SCUBAPRO[®]

Technical Service Reference & Repair Guide

SCUBAPRO®
Technical Service Update

SCUBAPRO ENGINEERING BULLETIN #234A
MK 15 HIGH PRESSURE SEAT UPGRADE KIT
 p/n 10-600-051 rev. C

SCUBAPRO® Mark 15 First Stage Piston & HP Seat Components

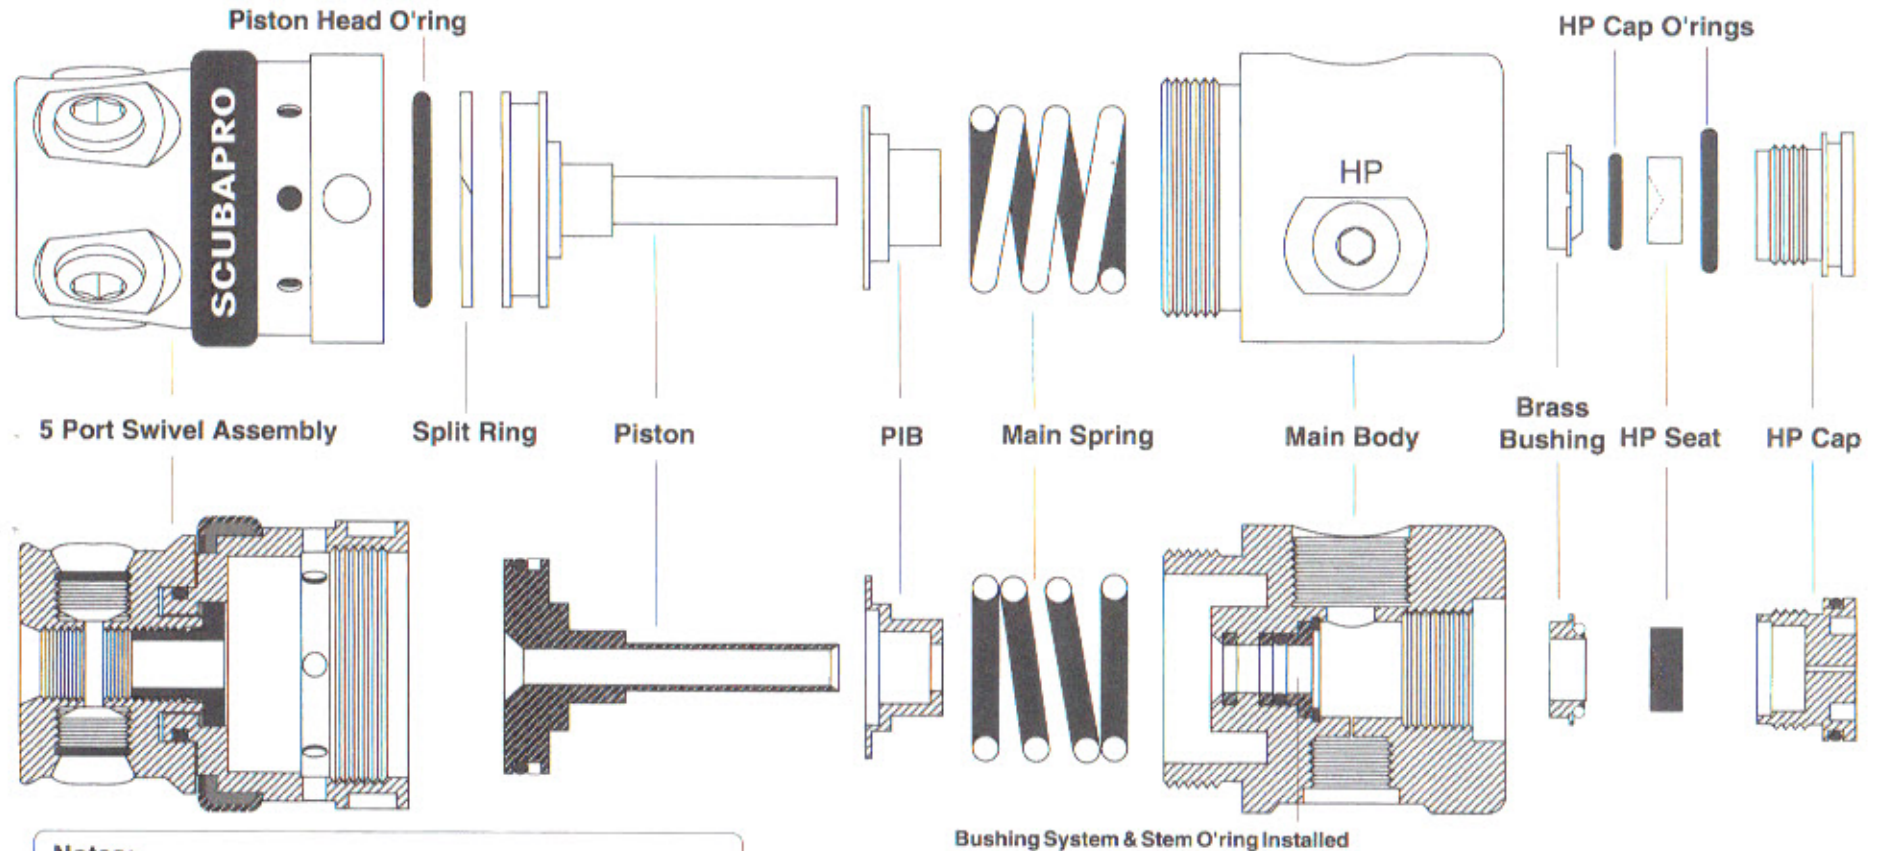
The components to the right are the original HP seat components used in the Mark 15 first stage. These were downgraded to 3000 psi. Replace with the components shown in the main illustration at the service interval.

Mark 15 Upgrade
Assembly

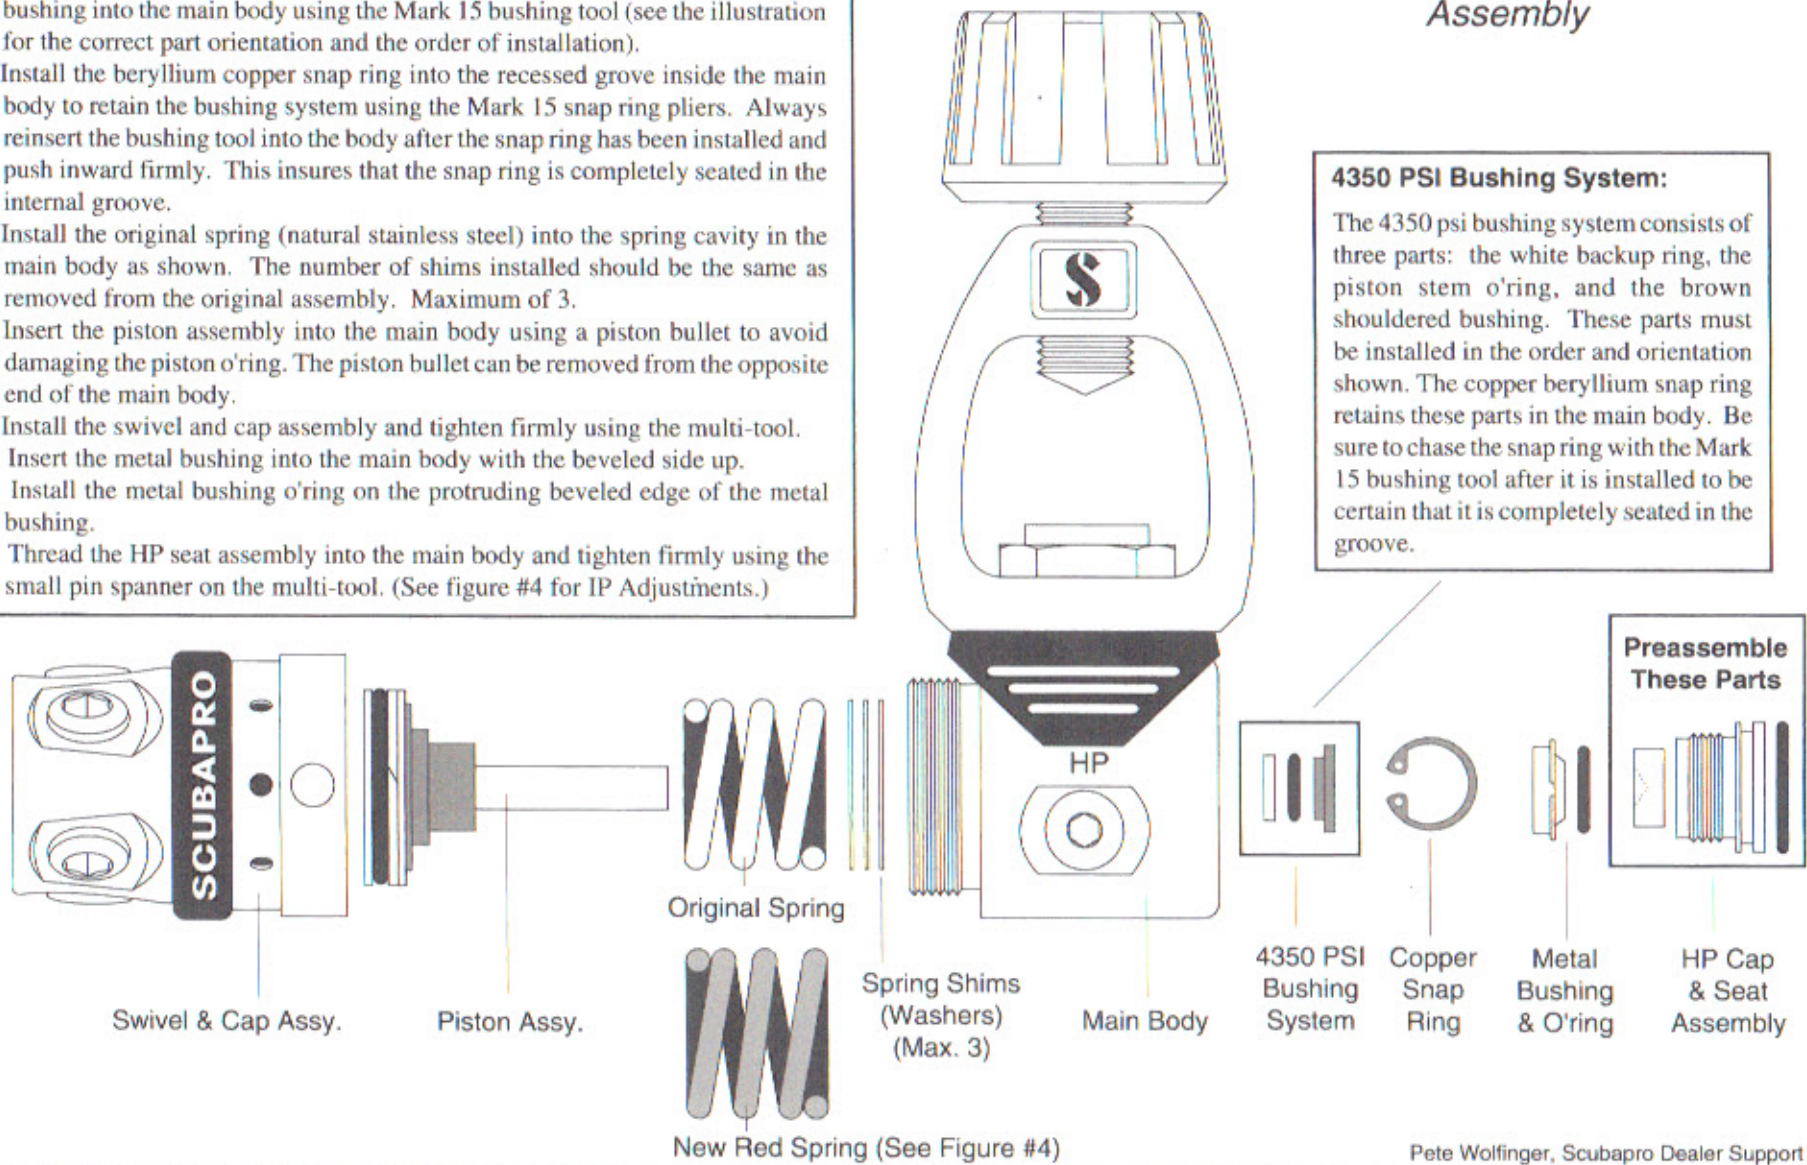
4350 PSI Bushing System:

The 4350 psi bushing system consists of three parts: the white backup ring, the piston stem o-ring, and the brown shouldered bushing. These parts must be installed in the order and orientation shown. The copper beryllium snap ring retains these parts in the main body. Be sure to chase the snap ring with the Mark 15 bushing tool after it is installed to be certain that it is completely seated in the groove.

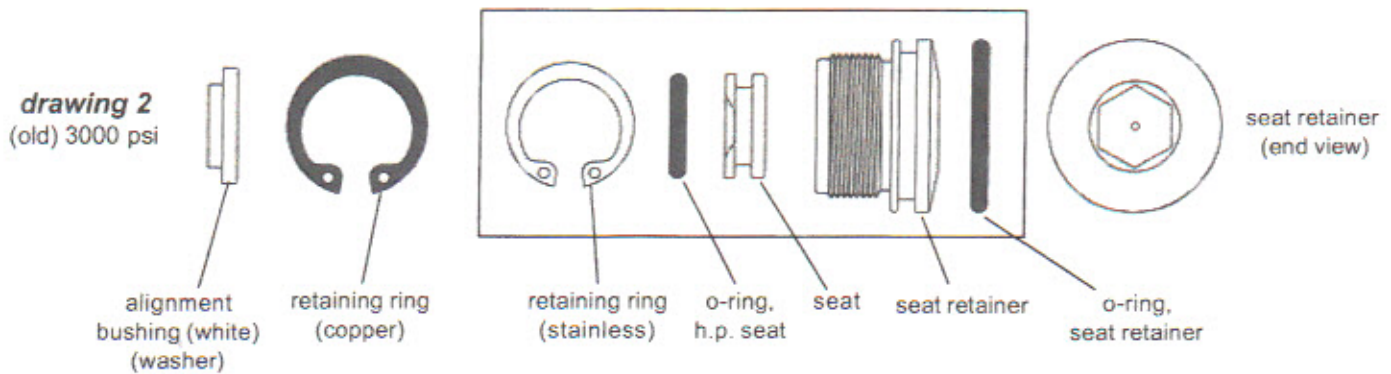
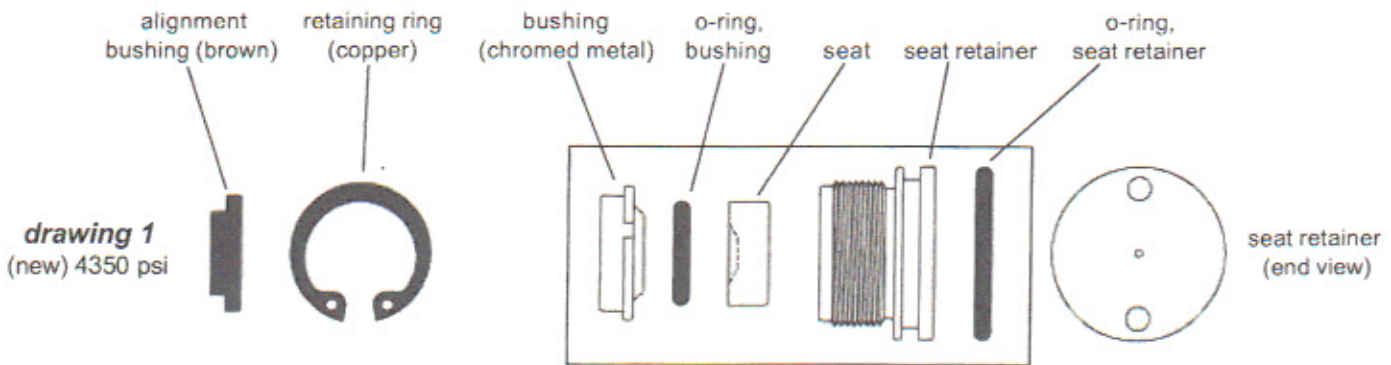
New parts are as follows: see drawing #1

o-ring, seat retainer	01-050-398
seat retainer	10-600-125
seat, h.p.	10-600-123
o-ring, bushing	01-050-401
bushing (chromed metal)	10-600-124
retaining ring (copper)	01-073-112
alignment bushing (brown plastic)	10-600-129
spring, (optional) not shown	01-020-601

Old parts to be discarded are: see drawing #2

o-ring, seat retainer	01-050-398
seat retainer	10-600-106
seat, h.p.	10-600-122
o-ring, h.p. seat	01-050-142
retaining ring (stainless)	01-073-114
retaining ring (copper)	01-073-112
bushing (white plastic)	10-600-105
decals, 3000 psi	01-006-431
